SUNDRY NOTICES AND REPORTS ON WELLS
Do not use this form for proposals to drill or to re-enter an abandoned well. Use form 3160-3 (APD) for such proposals.5. Lease Serial No.
NMNM94651

OXY USA Inc. respectfully requests the following bulk sundry changes to the approved APD's for the following wells:

1. Salt Flat CC 20-29 Federal Com #37H - 30-015-46369
2. Salt Flat CC 20-29 Federal Com #38H - 30-015-46399

OXY USA Inc. – Salt Flat CC 20-29 Federal Com 37H-38H – Amended Drill Plan

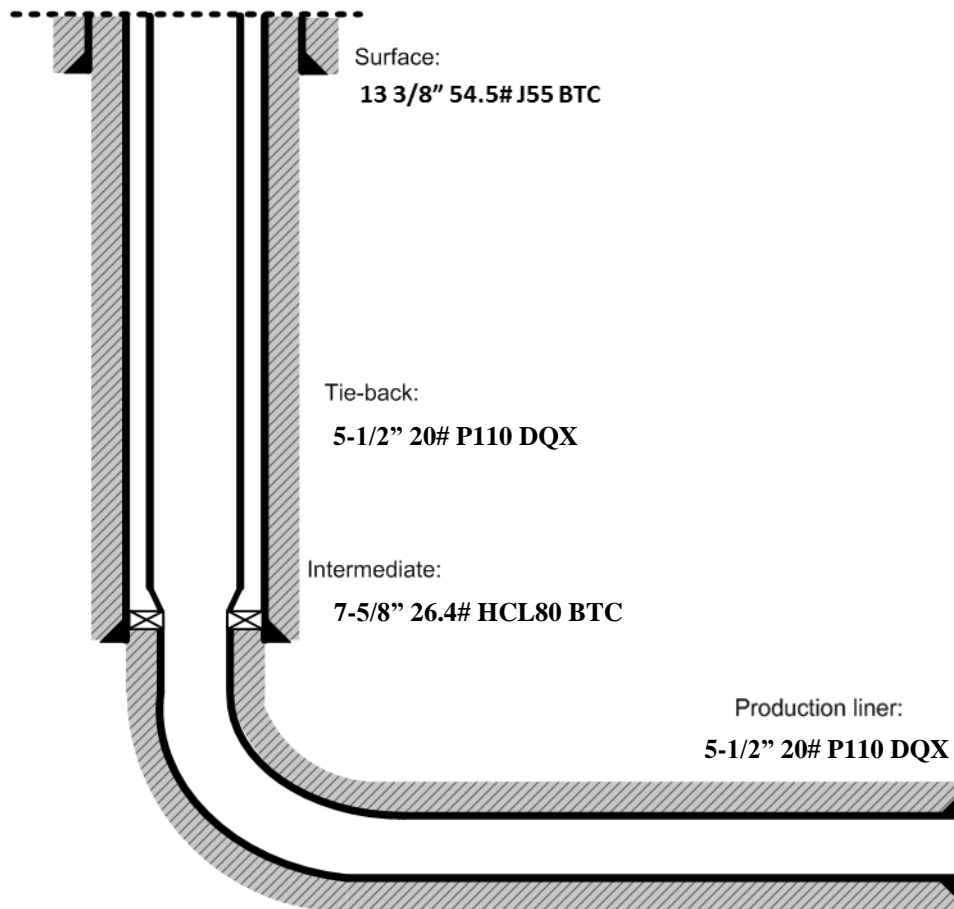
OXY respectfully requests a variance to cement the 9-5/8" and/or 7-5/8" intermediate casing strings offline.

The summarized operational sequence will be as follows:

1. Run casing as per normal operations. While running casing, conduct negative pressure test and confirm integrity of the float equipment (float collar and shoe).

2. Land casing.
3. Fill pipe with kill weight fluid, and confirm well is static.
 - a. If well is not static notify BLM and kill well.
 - b. Once well is static notify BLM with intent to proceed with nipple down and offline cementing.

4. Set and pressure test annular packoff.
5. After confirmation of both annular barriers and internal barriers, nipple down BOP and install cap flange. If any barrier fails to test, the BOP stack will not be nipped down until after the cement job is completed.

6. Skid rig to next well on pad.
7. Confirm well is static before removing cap flange.
8. If well is not static notify BLM and kill well prior to cementing or nipping up for further remediation.

9. Install offline cement tool.
10. Rig up cement equipment.
 - a. Notify BLM prior to cement job.
11. Perform cement job.
12. Confirm well is static and floats are holding after cement job.

13. Remove cement equipment, offline cement tools and install night cap with pressure gauge for monitoring.

- Contact the BLM prior to the commencement of any offline cementing procedure.

General well schematic:

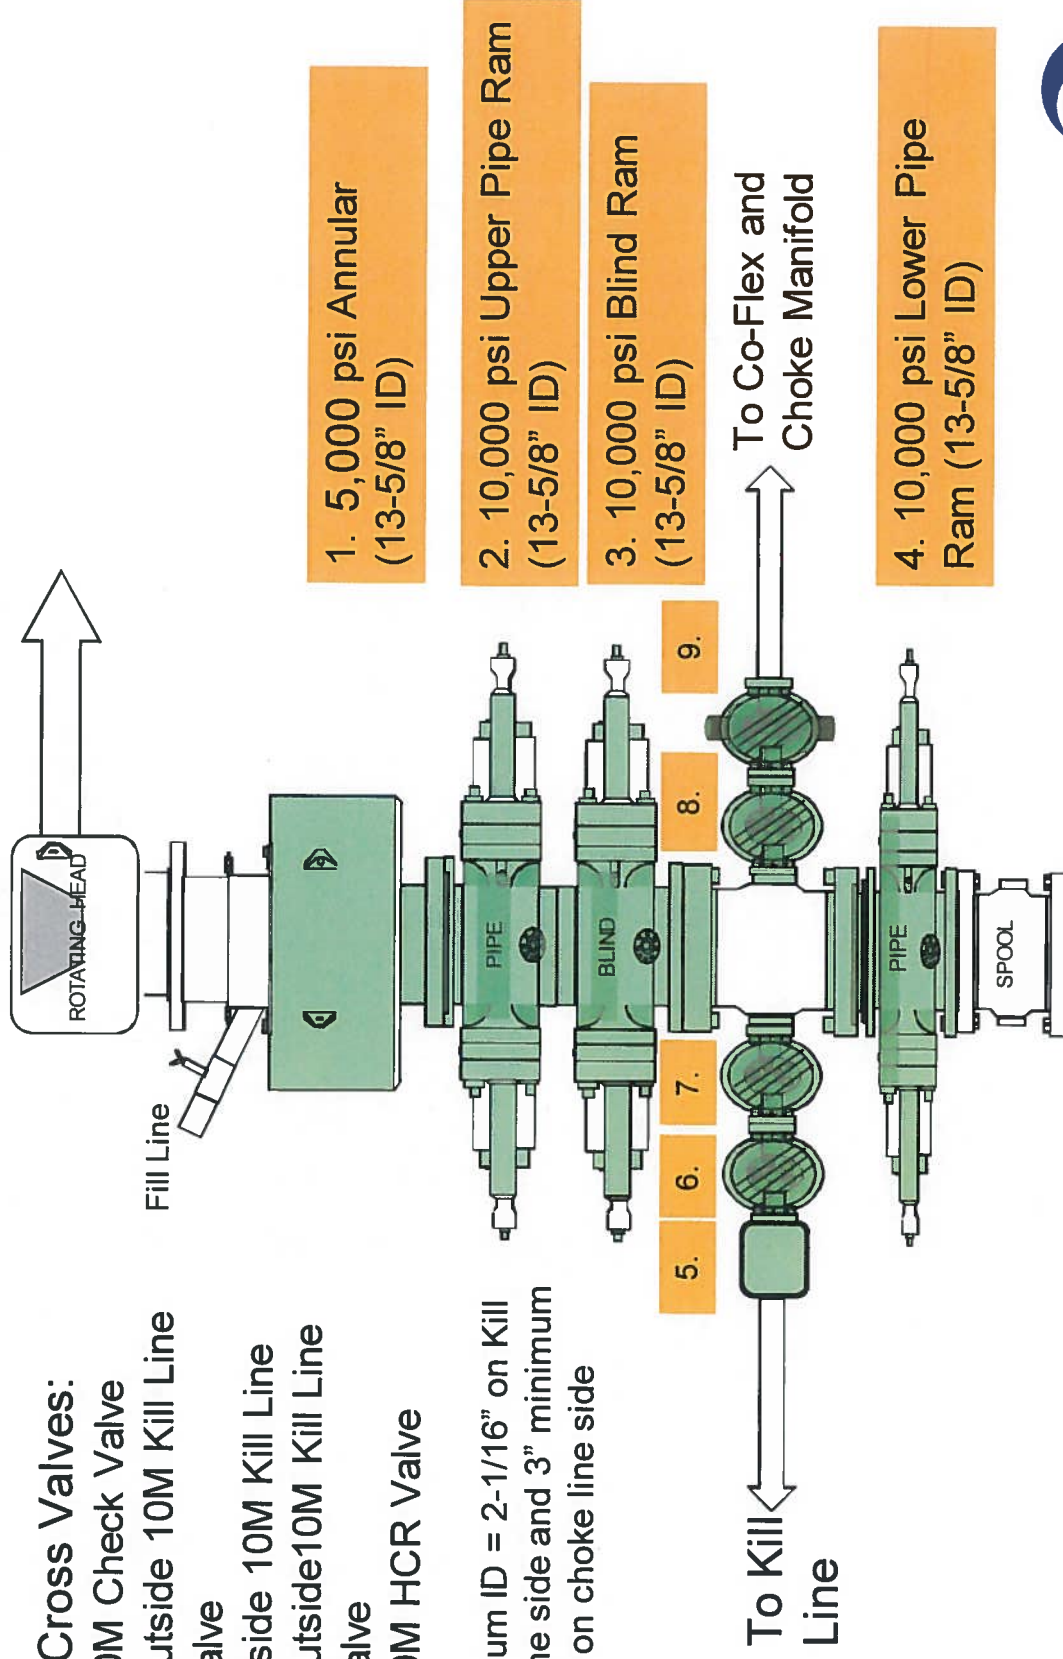
- Drill 17-1/2" hole x 13-3/8" casing for surface section. Cement to surface.
- Drill 9-7/8" hole x 7-5/8" casing for intermediate section. Cement to surface.
- Drill 6-3/4" hole x 5-1/2" liner for production section. Cement to top of liner, 100' inside 7-5/8" shoe.
- Release drilling rig from location.
- Move in workover rig and run a 5-1/2" 20# P110 DQX tie-back frack string and seal assembly (see connection specs below). Tie into liner hanger Polished Bore Receptacle (PBR) with seal assembly.
- Pump hydraulic fracture job.
- Flowback and produce well.

When a decision is made to develop a secondary bench from this wellbore, a workover rig will be moved to location. The workover rig will then retrieve the tie-back frack string and seal assembly before temporarily abandoning the initial lateral.

3. The minimum required fill of cement behind the **5-1/2** inch production liner is:
 - Cement should tie-back **100 feet** into the previous casing. Operator shall provide method of verification. **Excess calculates to 3% - additional cement might be required.**

5/10M BOP Stack

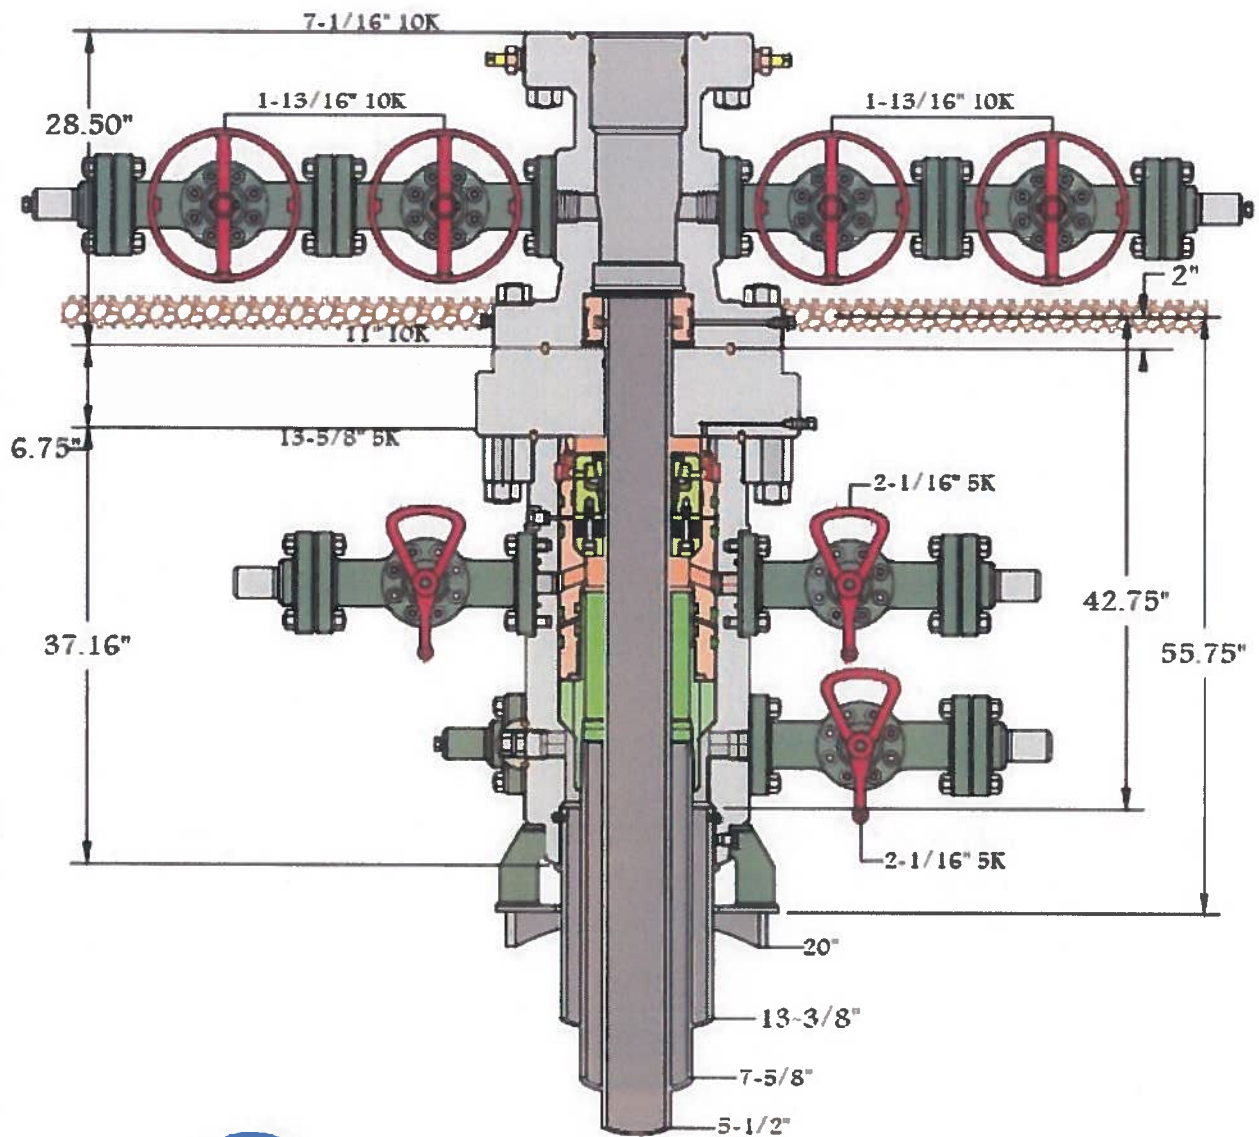
- 2. Request Bradenhead squeeze for the 2nd stage Intermediate casing with the Bradenhead CBL requirement.
- 3. Request Offline Intermediate Casing/Cementing Variance, see attached.
- 4. Update BOP Break Testing Request, Information and Plan
- 5. Update BOP/Wellhead Diagram

Oxy will utilize a 5M annular with a 10M BOPE stack. The BOP/BOPE will be tested by an independent service company to 250 psi low and the high pressure indicated above per Onshore Order 2 requirements. The System may be upgraded to a higher pressure but still tested to the working pressure listed in the table above. If the system is upgraded all the components installed will be functional and tested.

1. Operator has proposed a multi-bowl wellhead assembly. This assembly will only be tested when installed on the surface casing. Minimum working pressure of the blowout preventer (BOP) and related equipment (BOPE) required for drilling below the surface casing shoe shall be **5000 (5M)** psi.
